POLICY ISSUE (Notation Vote)

SECY-97-083

SUBJECT: CLASSIFICATION OF HANFORD LOW-ACTIVITY TANK WASTE FRACTION
AS INCIDENTAL

Figure 2-1. Estimate Hanford Site Tank Waste Radionuclide Inventory^{c,d}

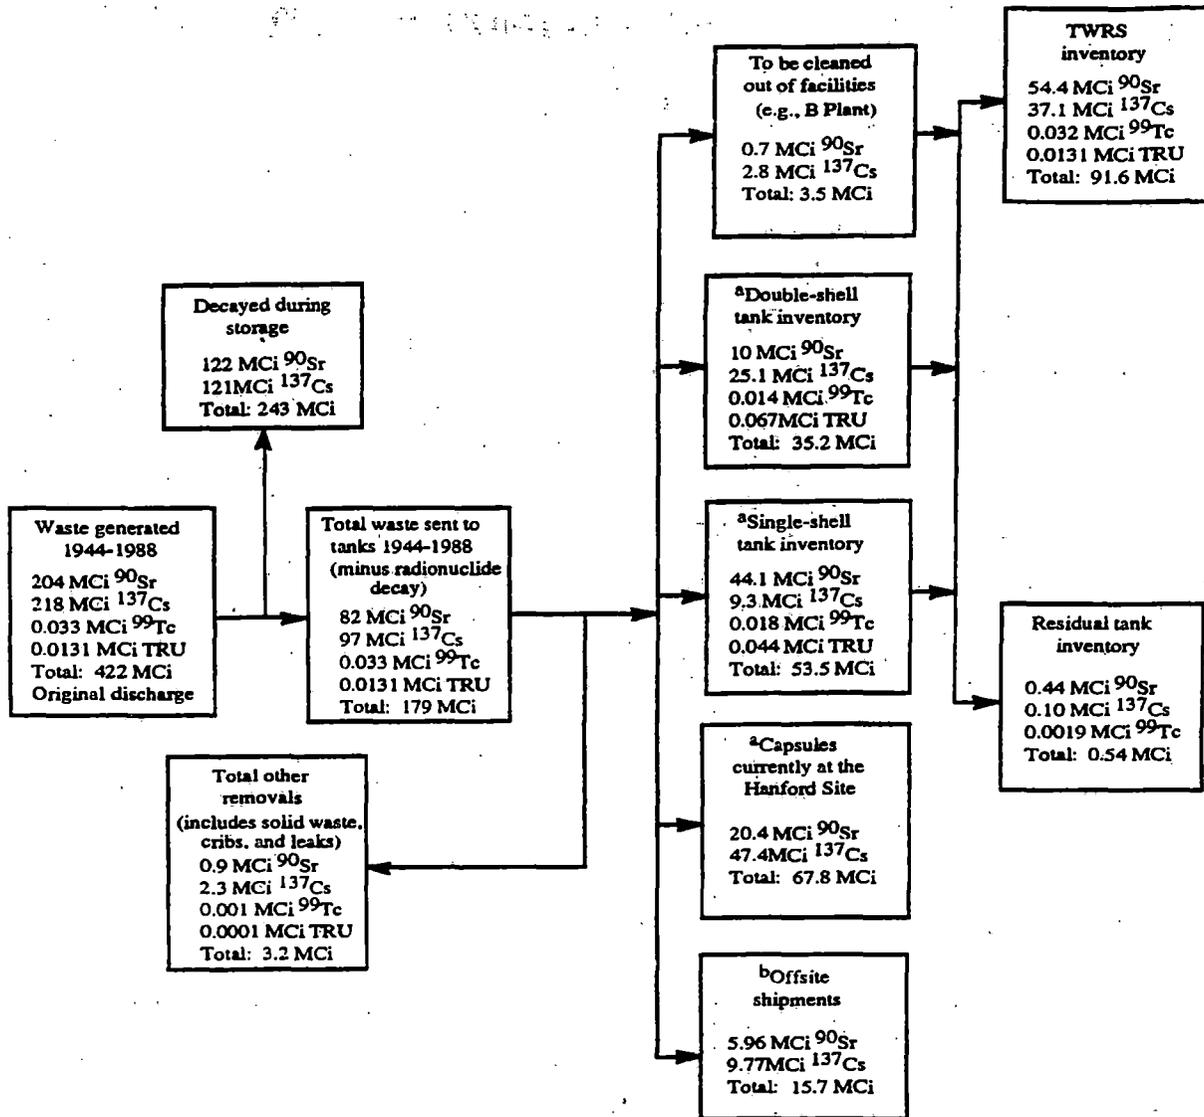
Figure 2-1, reproduced from the TBR (Westinghouse Hanford Company, 1996a, p. 3-2, figure 3-1), provides the estimated material balance for the Hanford Site tank waste radionuclide inventory. Figure 2-1 indicates that 243 MCi of the original tank waste radionuclide content of 422 MCi will have decayed by the year 1999. This value reflects the relatively short half lives of ¹³⁷Cs and ⁹⁰Sr. The material balance also indicates that approximately 87 MCi are accounted for as (i) leaks or deliberate discharges, (ii) encapsulation of ¹³⁷Cs and ⁹⁰Sr, (iii) other offsite shipments, or (iv) residual tank inventories. The remaining 91.6 MCi consists of 55.6 MCi insoluble waste to be disposed in a geologic repository as HLW and 36 MCi that comprises the soluble radionuclides that will be further treated to produce what DOE proposes to classify as incidental waste. This 36 MCi contains most of the ¹³⁷Cs and ⁹⁹Tc and almost all of the ⁷⁹Se, ¹²⁹I, ¹⁴C, and ³H (Westinghouse Hanford Company, 1996a, p. 4-1). After further treatment, 8.5 MCi will remain as incidental waste with 27.5 MCi being added to the HLW stream.

As shown in figure 2-1 of this report, 91.6 MCi comprises the Hanford Site tank waste inventory that will be processed for disposal as HLW or LLW. Approximately 99.9 percent of this waste is ^{137}Cs or ^{90}Sr . Initially, a simple solids-liquids separation will be performed on this waste to yield a low-activity liquid fraction containing the bulk of the nonradioactive materials, including about 3 percent solids carryover, and a high-activity fraction containing most of the solids. This solids-liquids separation process is expected to be relatively simple to complete and will remove approximately 55.6 MCi, consisting primarily of ^{90}Sr and TRU radionuclides (Westinghouse Hanford Company, 1996a, pp 3-2, 4-1, 4-2). Chapter 5 of the TBR concludes that, with the additional selective removal of transuranic wastes from three complexant concentrate tanks, and single-cycle ion exchange removal of ^{137}Cs from certain wastes,
